CITY OF ALBUQUERQUE

Re: Barlow Shop
6205 Wilshire Ave NE
Traffic Circulation Layout
Engineer's/Architect's Stamp 12-11-19 (C18D070)

BP-2019-36846

Site Plan

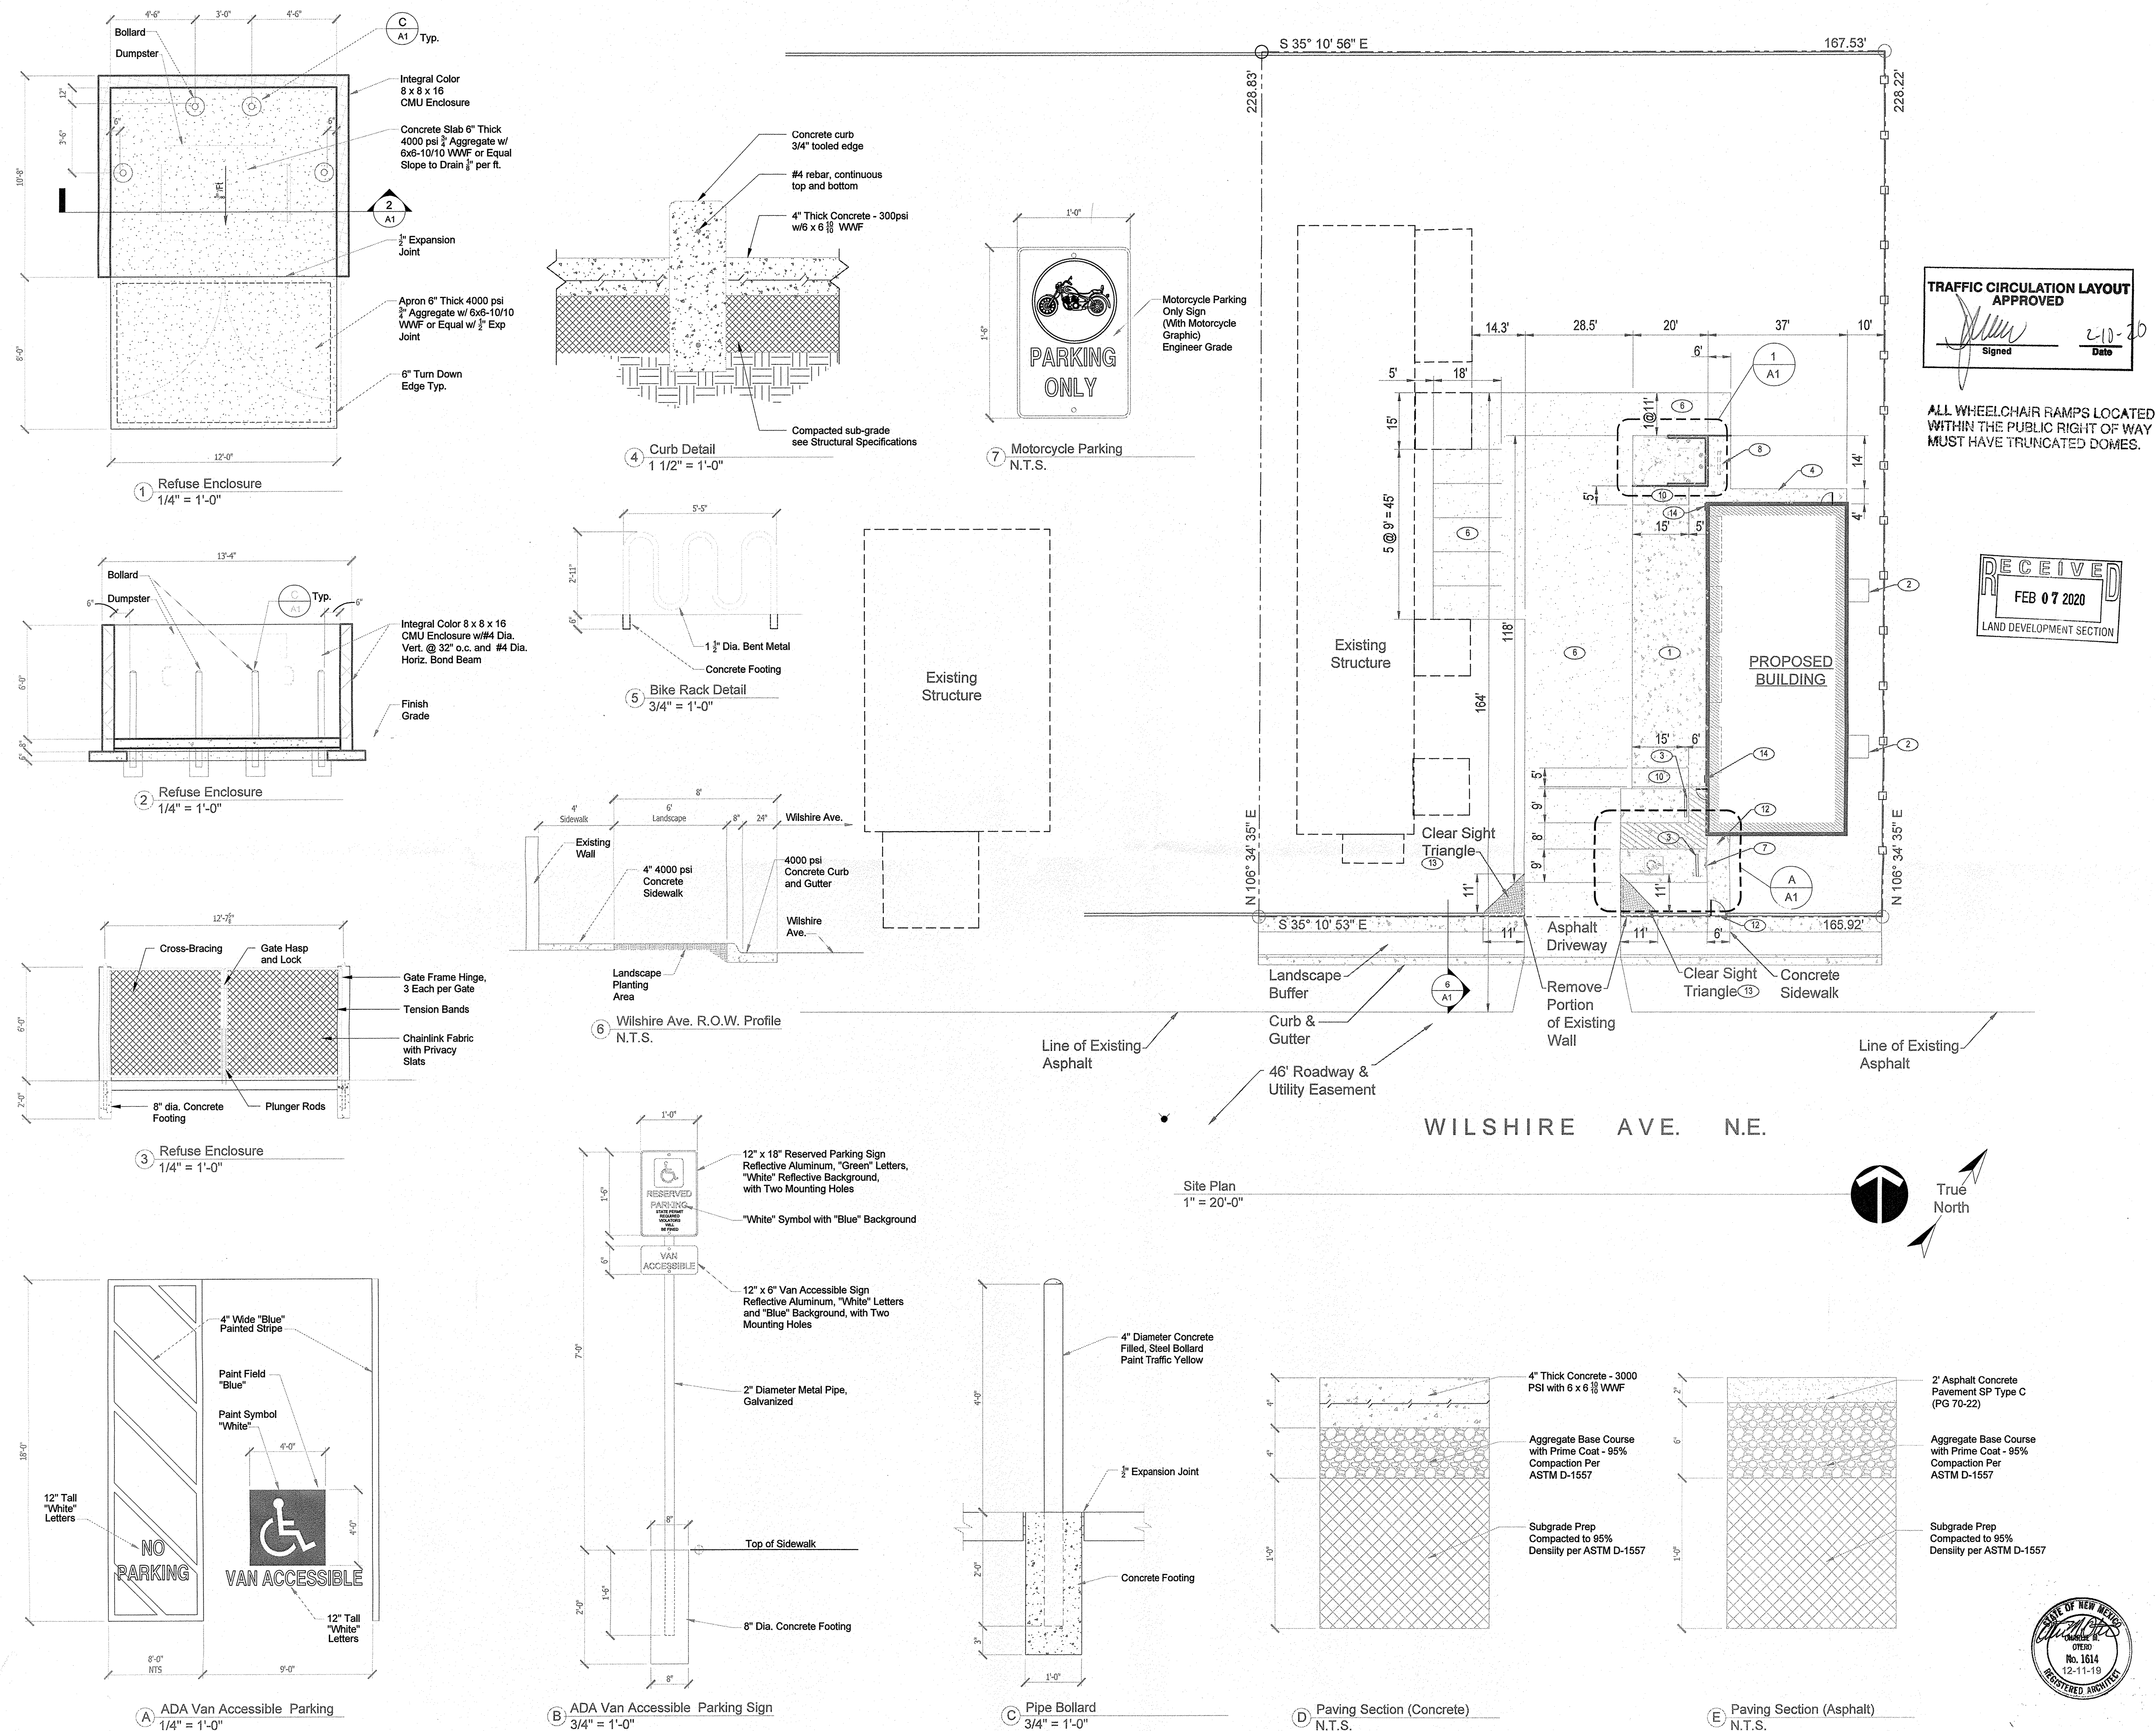
The TCL submittal received 1-7-2020 is approved for Building Permit with. A copy of the stamped and signed plan will be needed for each of the building permit plans. Please keep the original to be used for certification of the site for final C.O. for Transportation.

When the site construction is completed and an inspection for Certificate of Occupancy (C.O.) is requested, use the original City stamped approved TCL for certification. Redline any minor changes and adjustments that were made in the field. A NM registered architect or engineer must stamp, sign, and date the certification TCL along with indicating that the development was built in "substantial compliance" with the TCL. Submit this certification, the TCL, and a completed Drainage and Transportation Information Sheet to front counter personnel for log in and evaluation by Transportation.

Solid Waste	Carla Wilkins cwilkins@cabq.gov	christinachavez@cabq.gov	AuthorizedWithConditions	CO Required. Approved. Carla Wilkins 1-8-20. Refuse service will need to be a roll-out dumpster only, due to the angle of the new/proposed refuse enclosure indicated on both the Revised Site Plan (Pg. A1 for 1-7-20) and the TCL Site Plan. All Pre-Pour Inspections must be done by Solid Waste Department.
